- **Thesis Title: Wide Dynamic Range CMOS Image Sensor for Star Tracking Applications**

## Reviewer: 1

Fig. 1 Measurement setup.

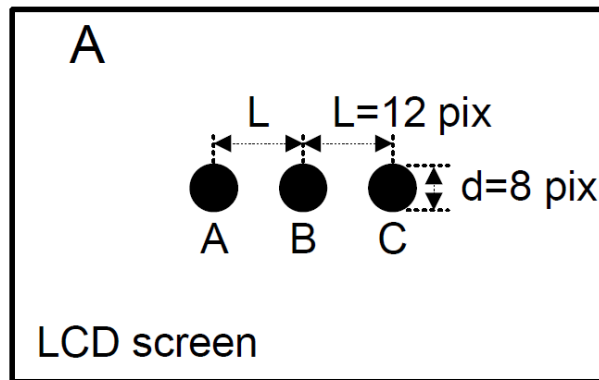
*In this chapter, it is mentioned that the relative centroiding performance with limited integration time compared to commercial image sensor is 1% higher. Please explain on possible measurement error and its contribution in percentage.*

**Reply:** The measurement attempts to measure the distance (AB and BC) of three simulated "stars" spots (A, B and C) from an LCD screen as shown in Fig. 1. This is for the purpose of evaluating the centroiding performance. The measurement result is represented as relative error (AB/BC-1) in percentage in comparison with the "ground truth" equidistance (AB=BC=12 LCD pixels). To make it a fair comparison between my sensor and the commercial image sensor, this measurement setup was unchanged throughout the test.

Possible sources of the measurement error can come from the LCD screen. The LCD screen is not a perfect light source. It has bad black emissivity and ill-controlled bright emission so that within each spot, the “ground truth” can deviate from its designed position, which adds to the measurement error in the sensors. From the sensors’ perspective, the SNR (signal quality and noise performance) also determines the accuracy. The commercial has rather low sensitivity. With limited integration time, the obtained signal magnitude is not sufficient to lead to fair centroiding accuracy. Other possible erroneous source may be in the optical system, such as, lens aberration and the extent of the focusing.
